TH Management - Rochester Hills

<p>J2024-0082 PSP2024-0007 Revision #2 Received 8/1/2024</p>	<p>City of Rochester Hills Planning & Economic Development</p>
--	---

Site Plan Review
Reviewed for compliance with City Ordinance, Building and Fire Codes
Conditions and mark-ups noted throughout plan set must be addressed prior to final approval

PROJECT DESCRIPTION
EXTERIOR RENOVATION OF COMMON AREA INCLUDING: PICKLE BALL COURTS, TENNIS COURTS, VOLLEYBALL COURT, POOL/SPLASHPAD, POOL HOUSE, PLAYGROUNDS, AND GREEN SPACES.

TITLE:
DEMOLITION & TREE REMOVAL PLAN

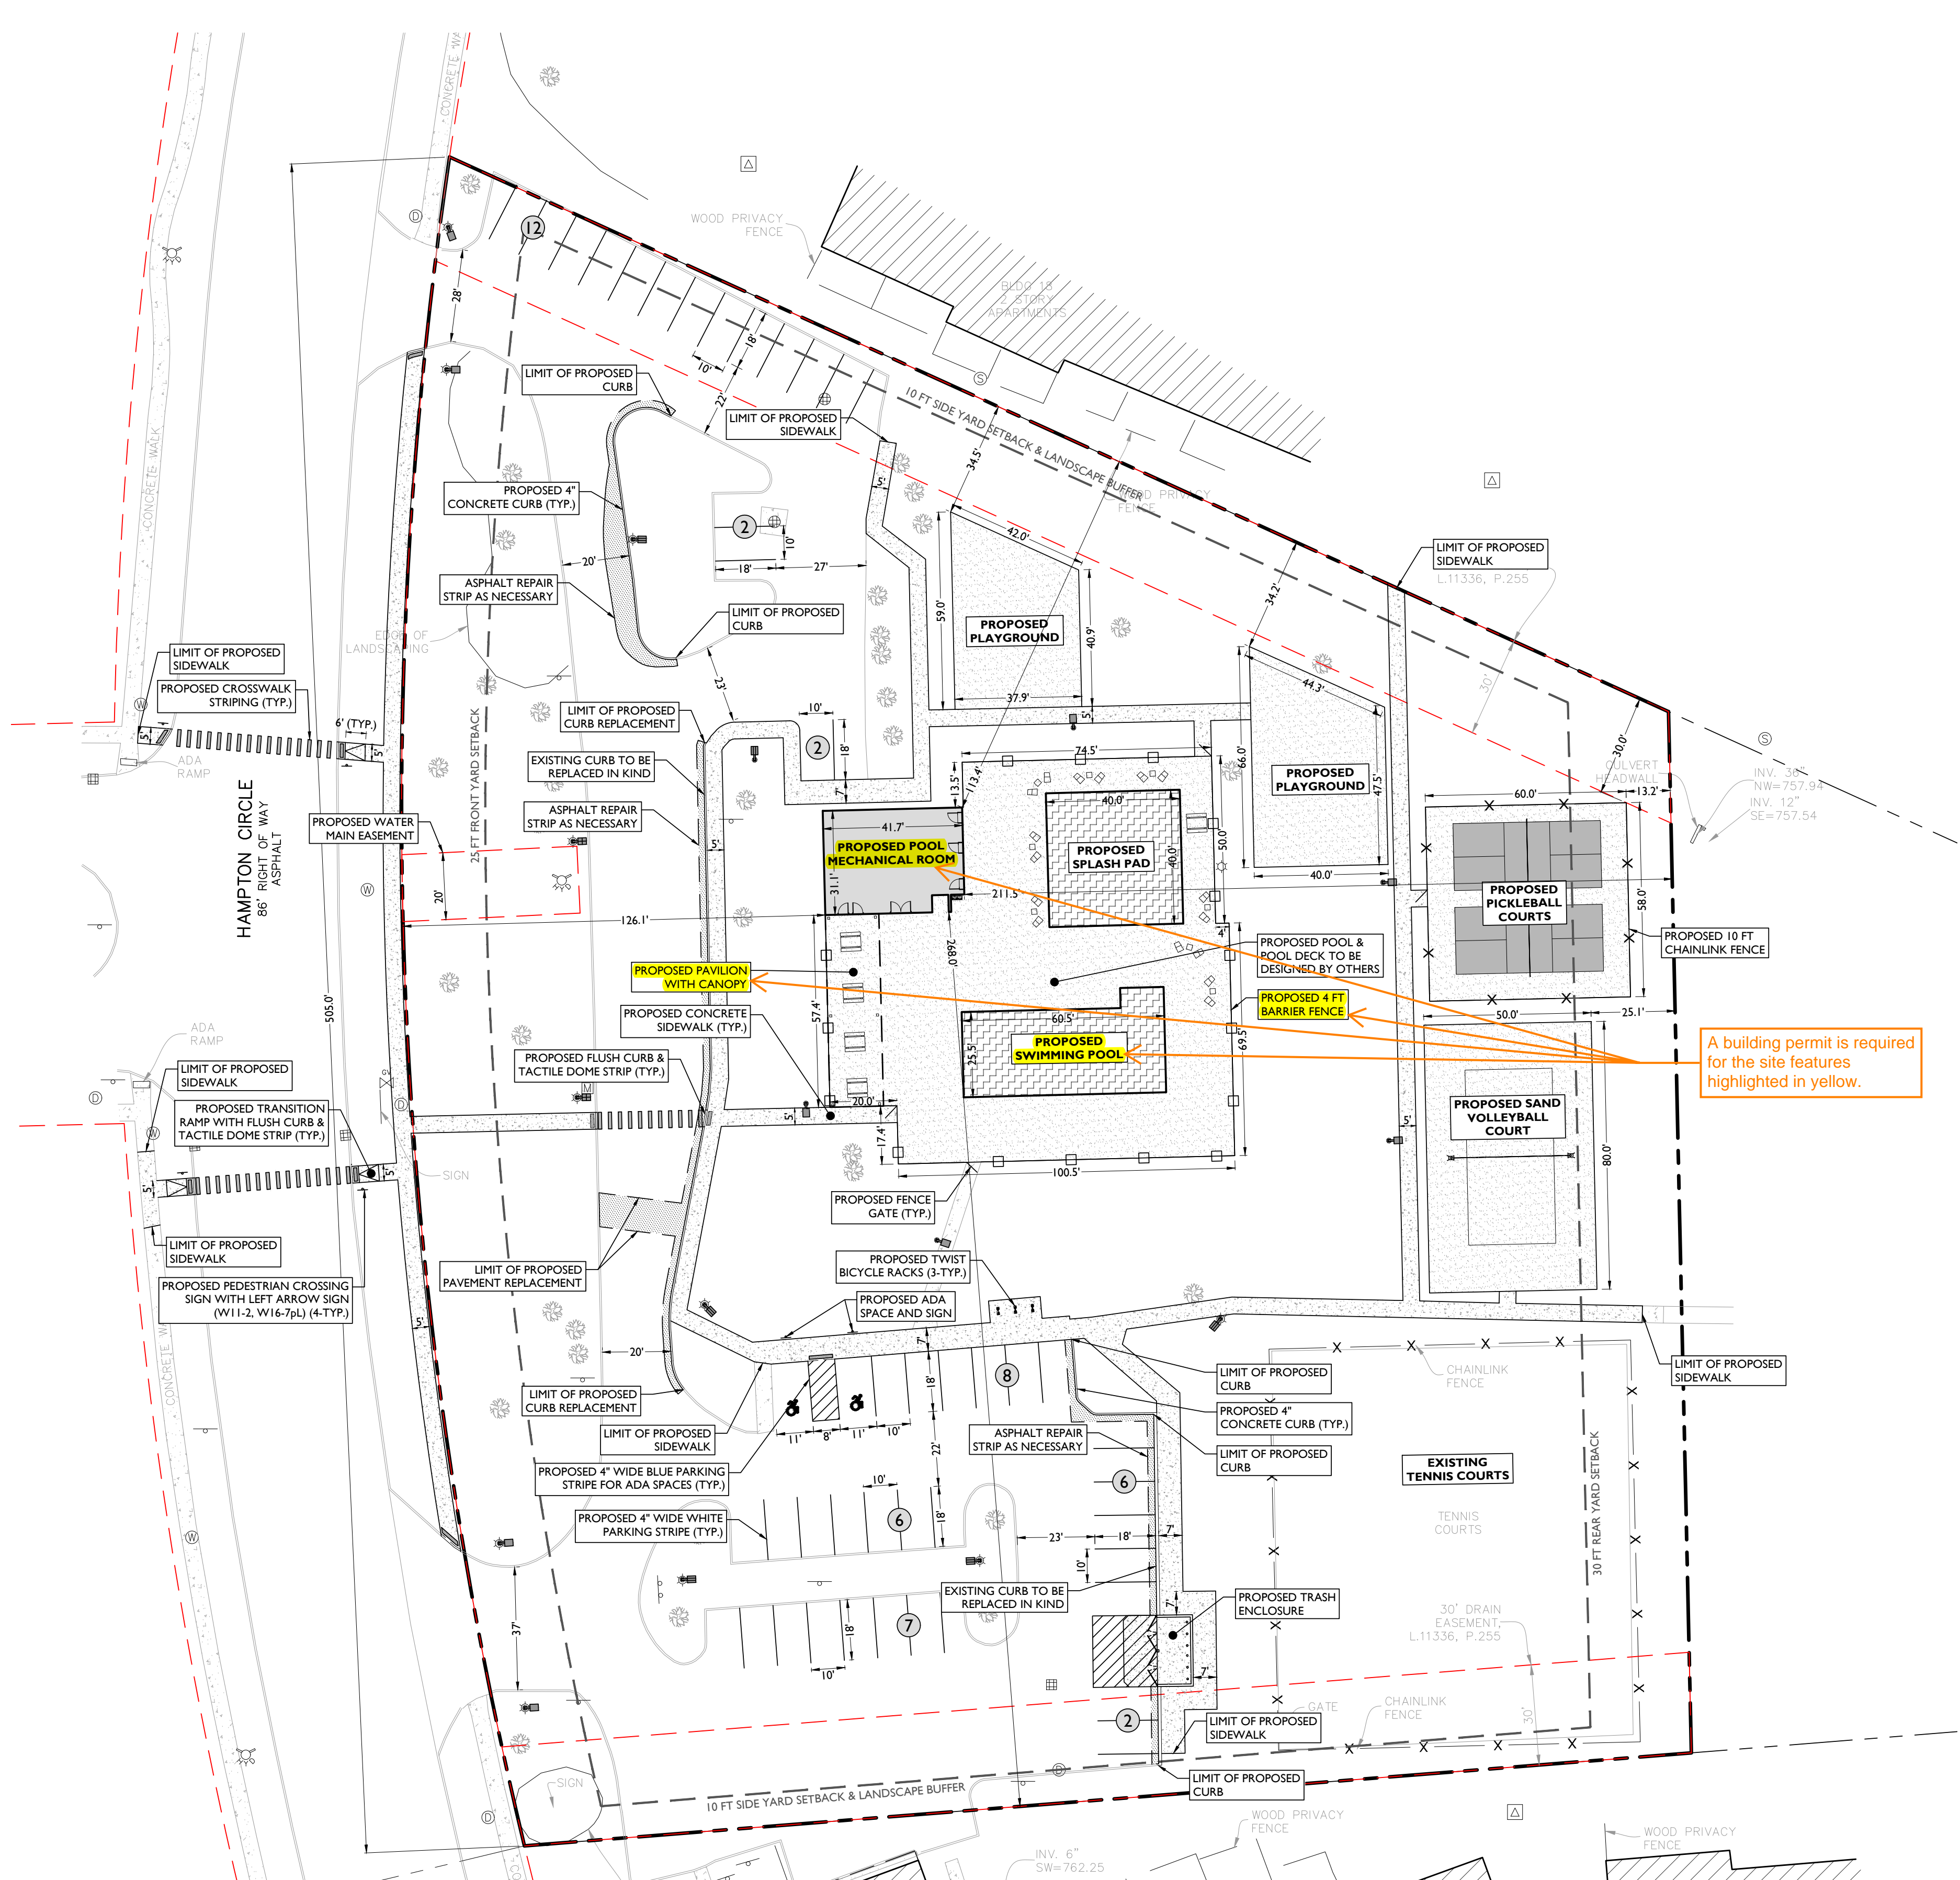
Shown as removed on plan - update table

TITLE:
GRADING PLAN &
STORMWATER
MANAGEMENT PLAN

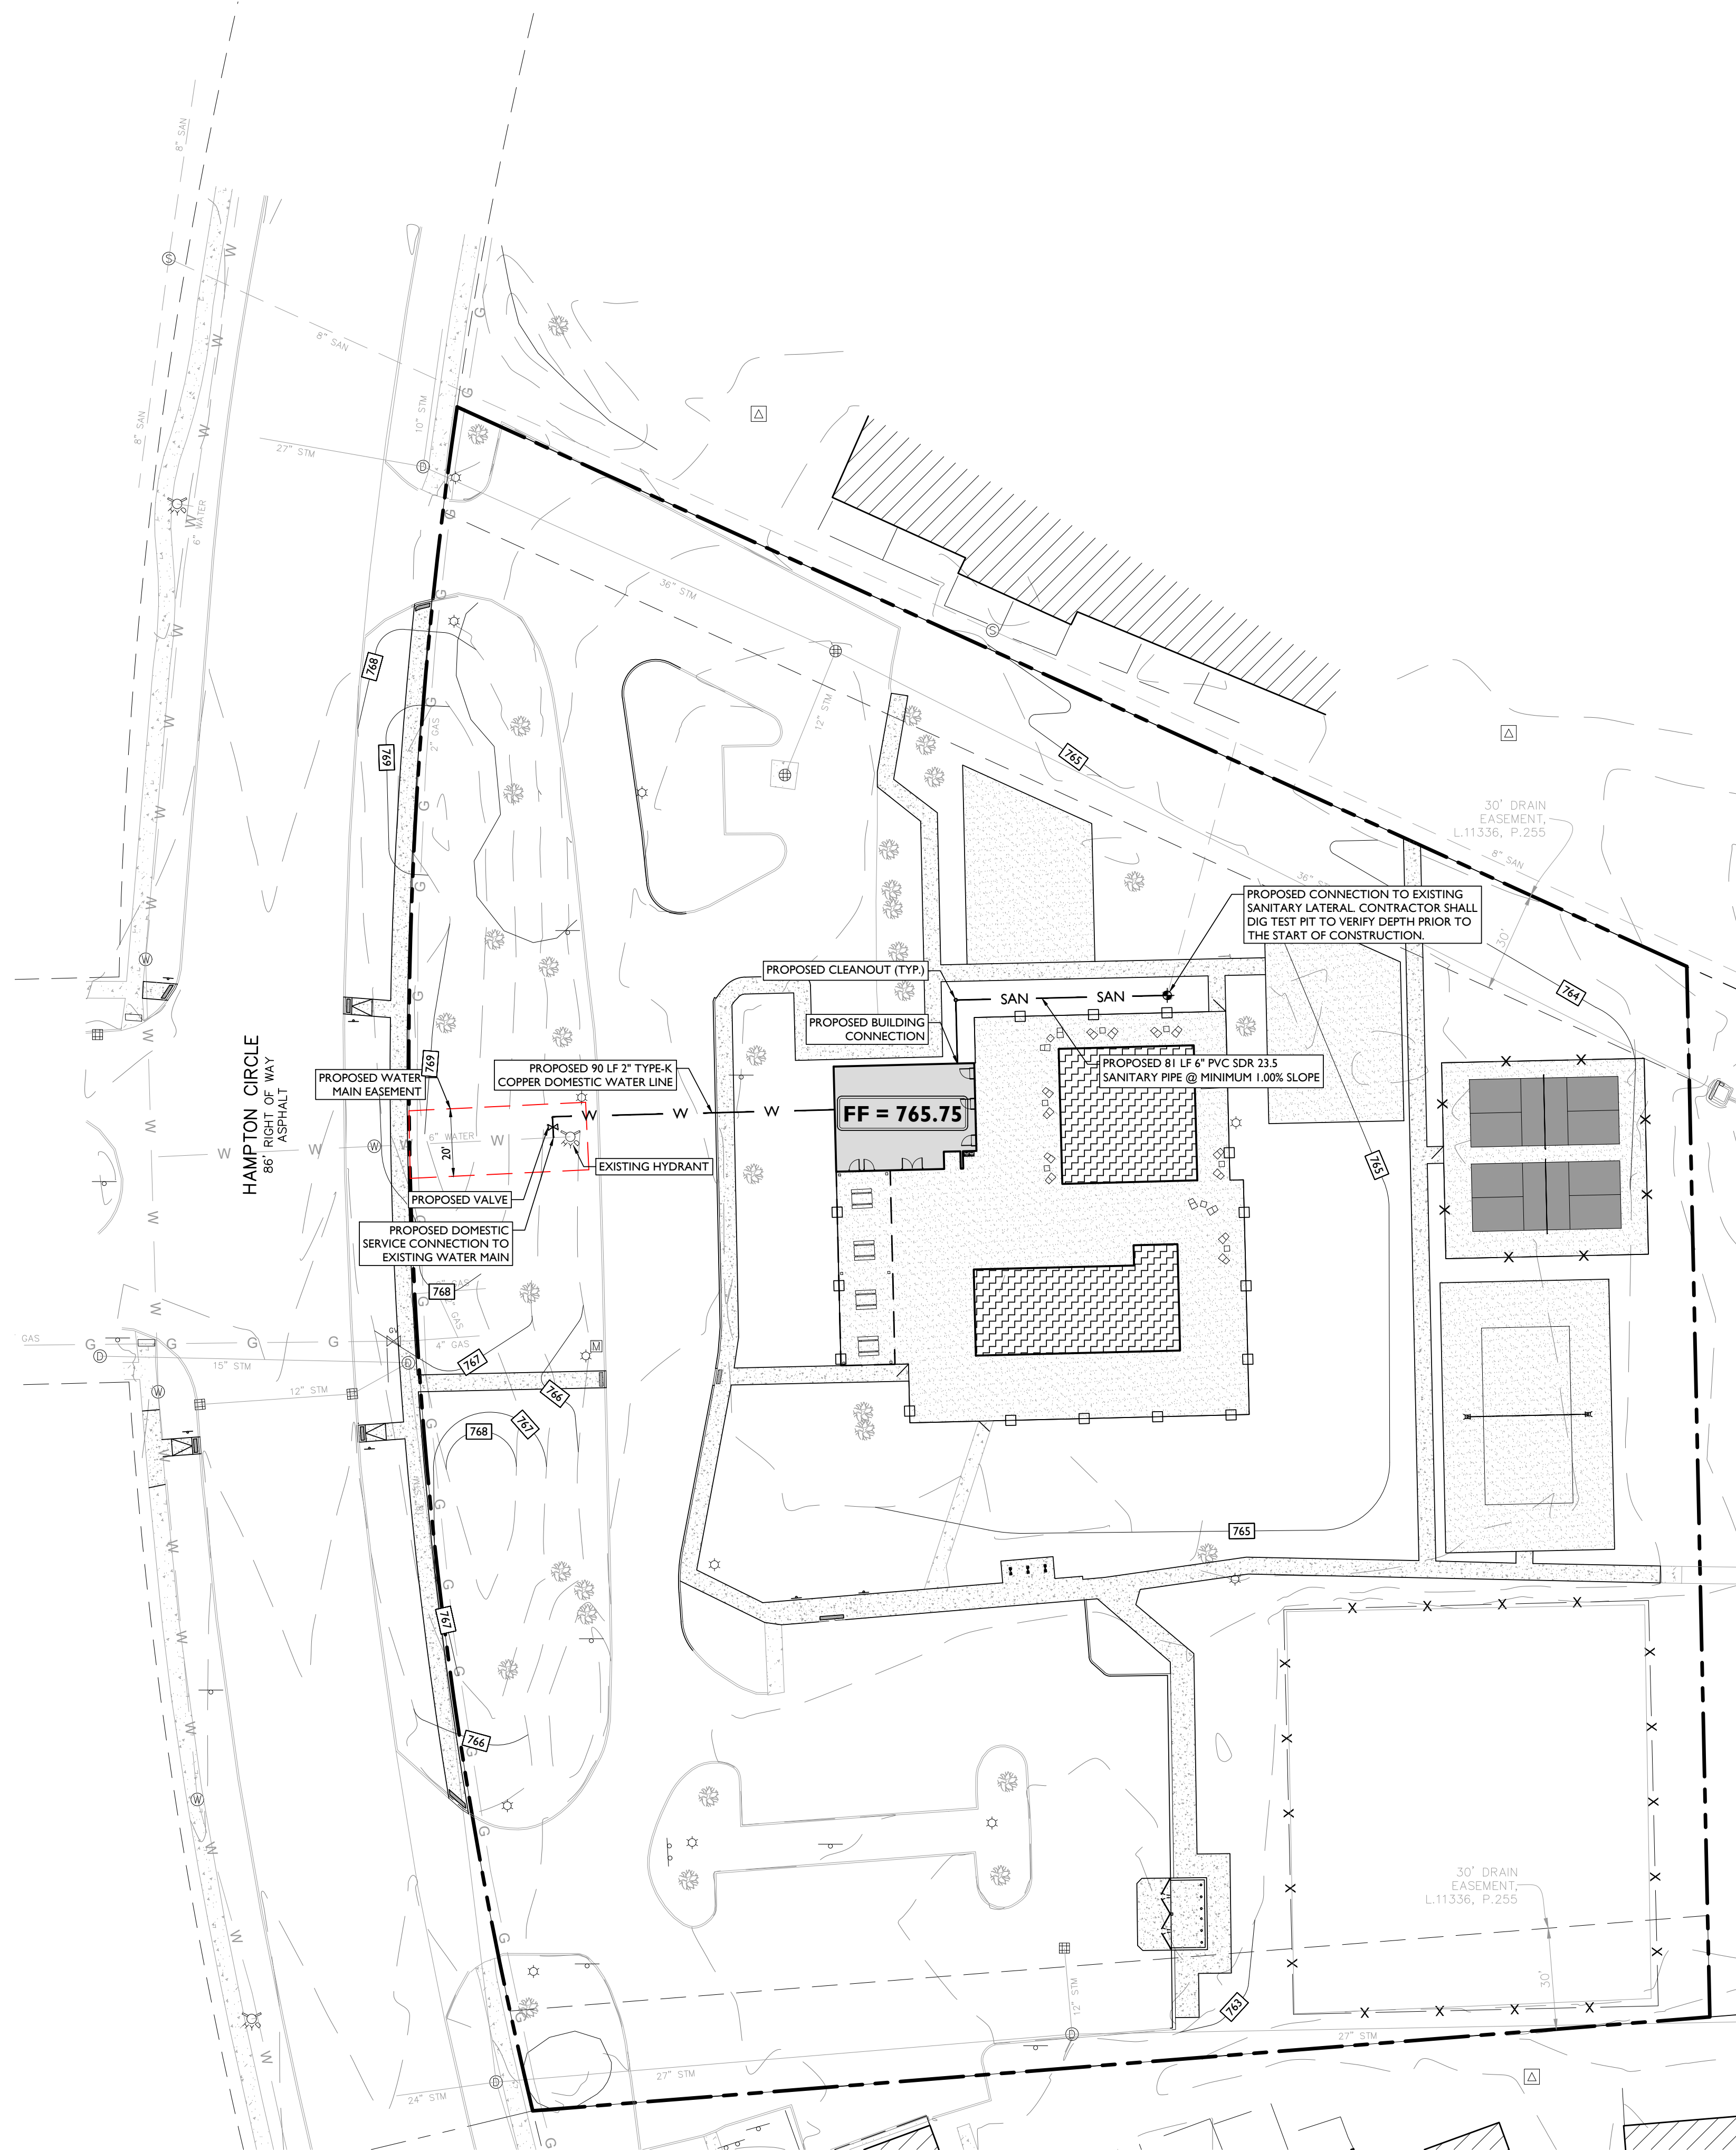
This proposed redevelopment falls within the Hampton Drain District. A WRC storm sewer permit may be necessary. During the construction plan phase it will be determined what storm improvements are necessary for this redevelopment.

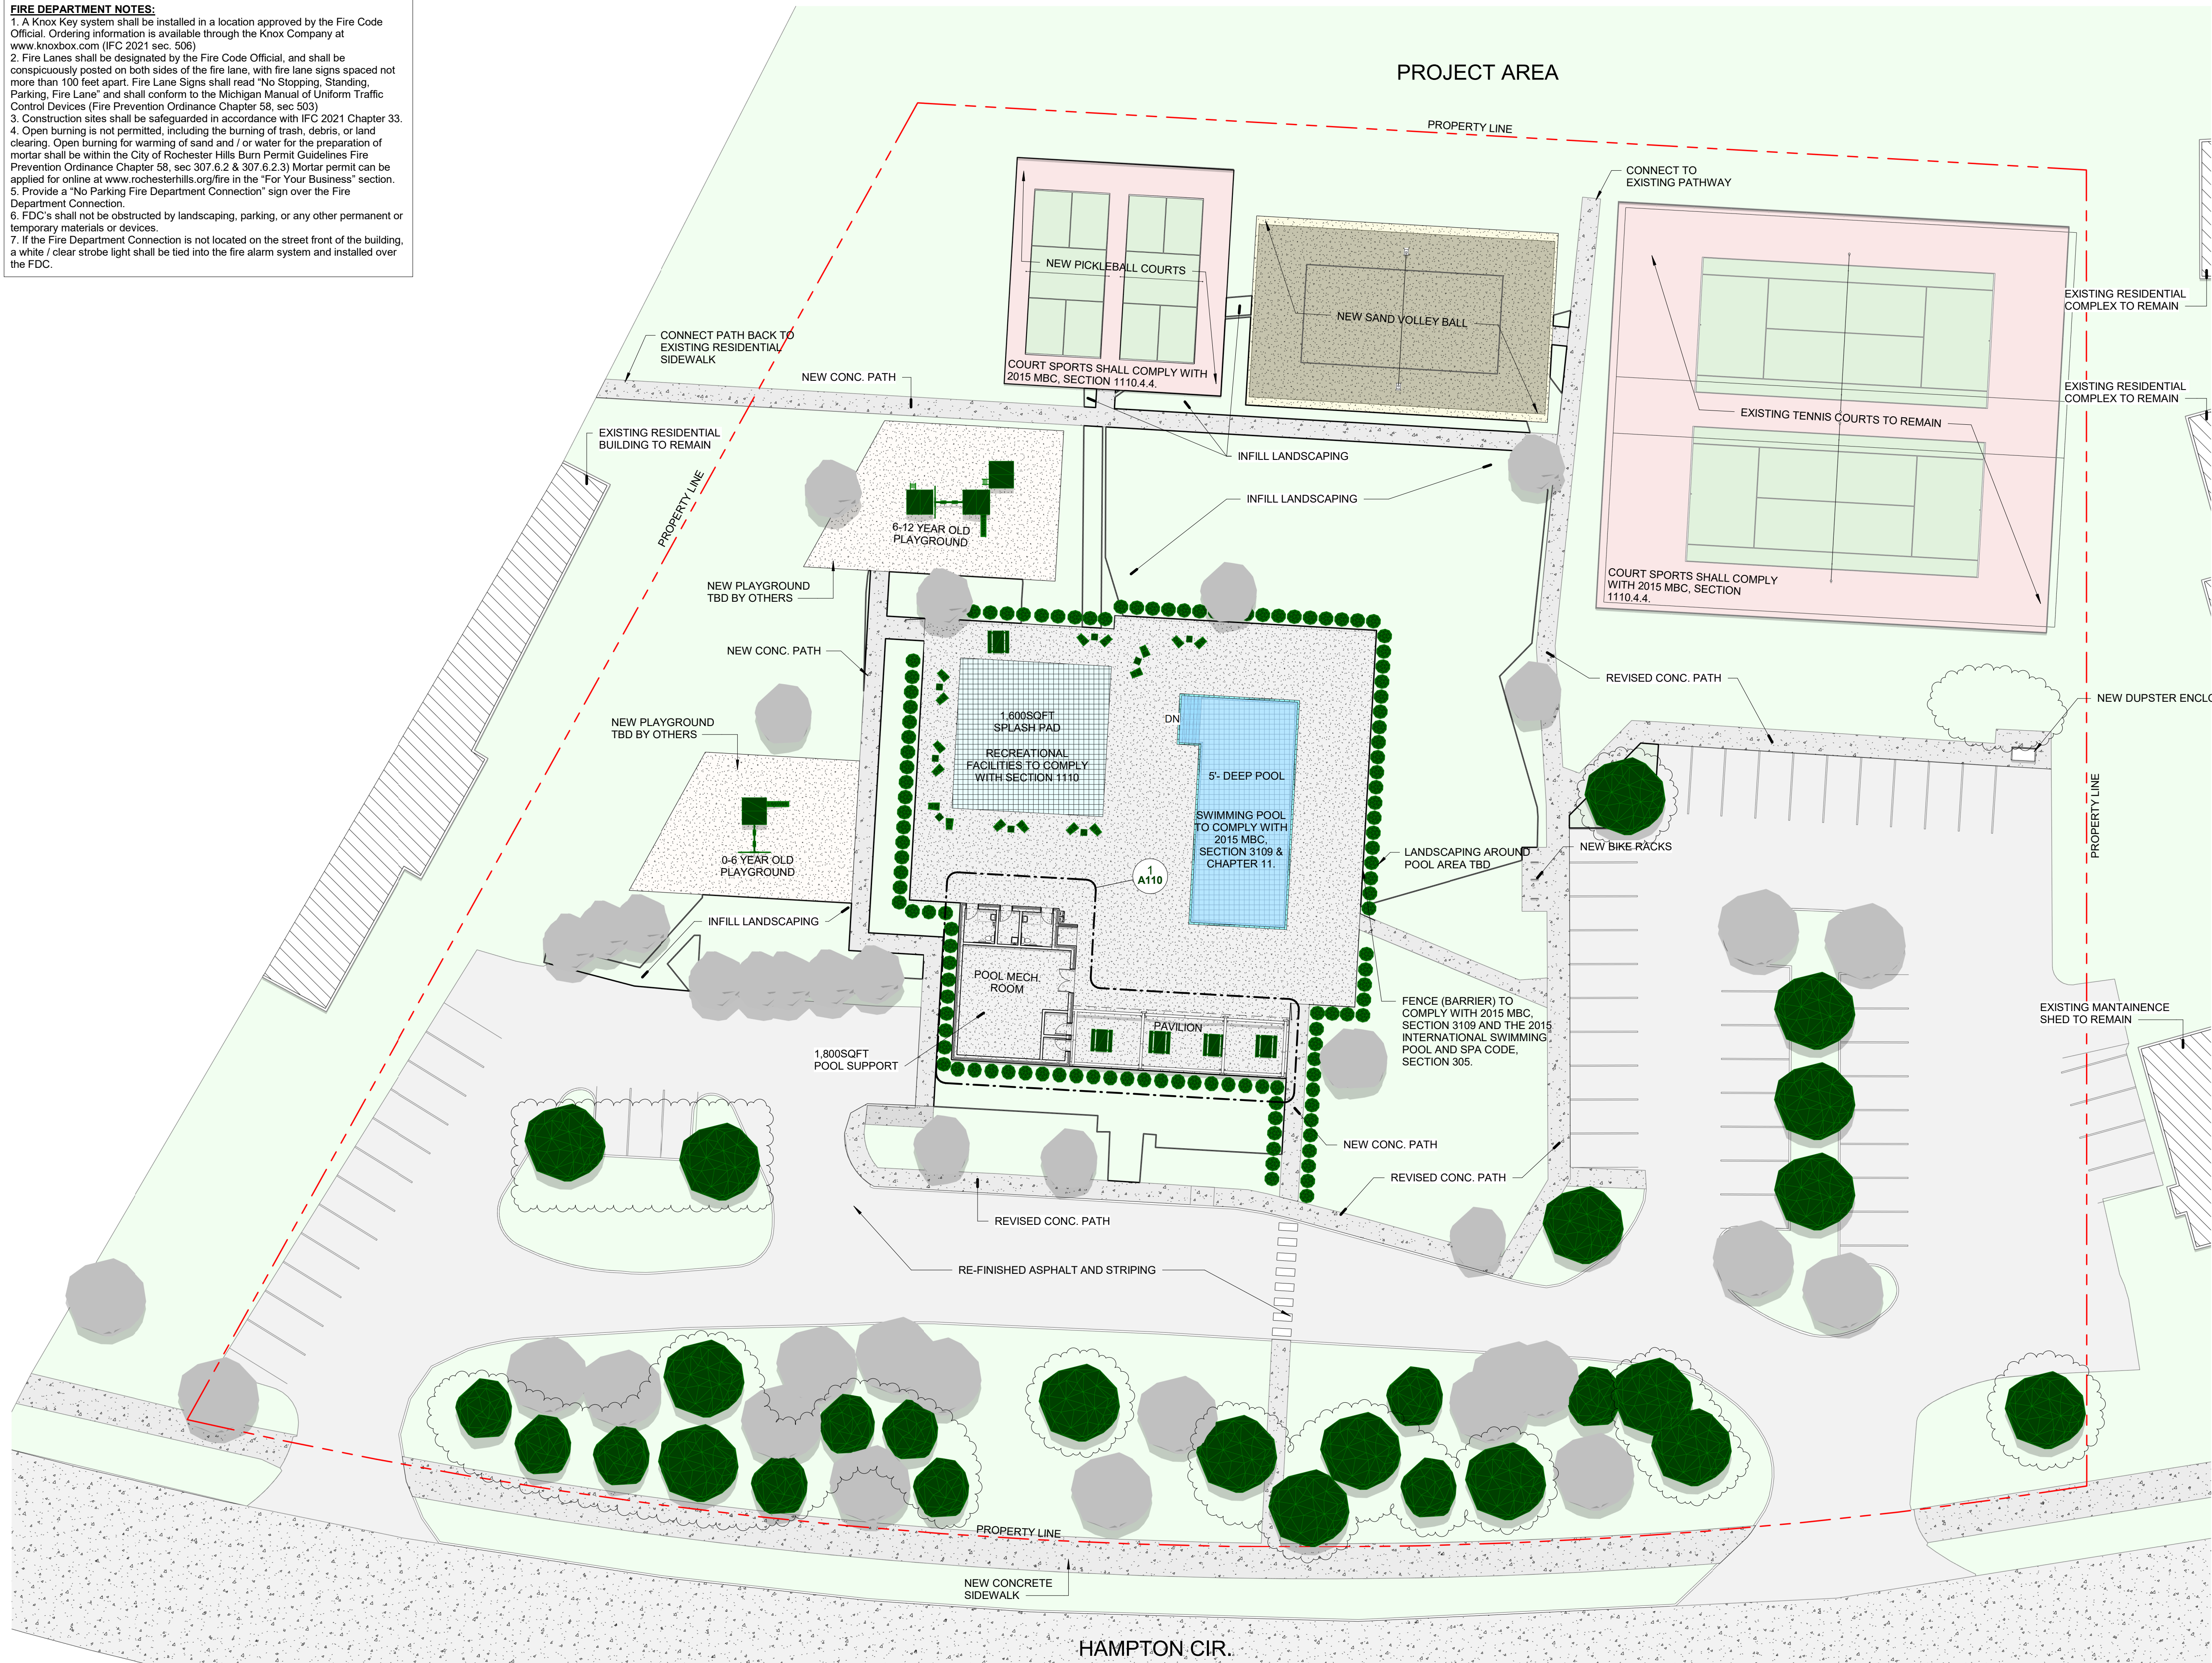
1. A Knox Key system shall be installed in a location approved by the Fire Code Official. Ordering information is available through the Knox Company at www.knoxbox.com (IFC 2021 sec. 506)
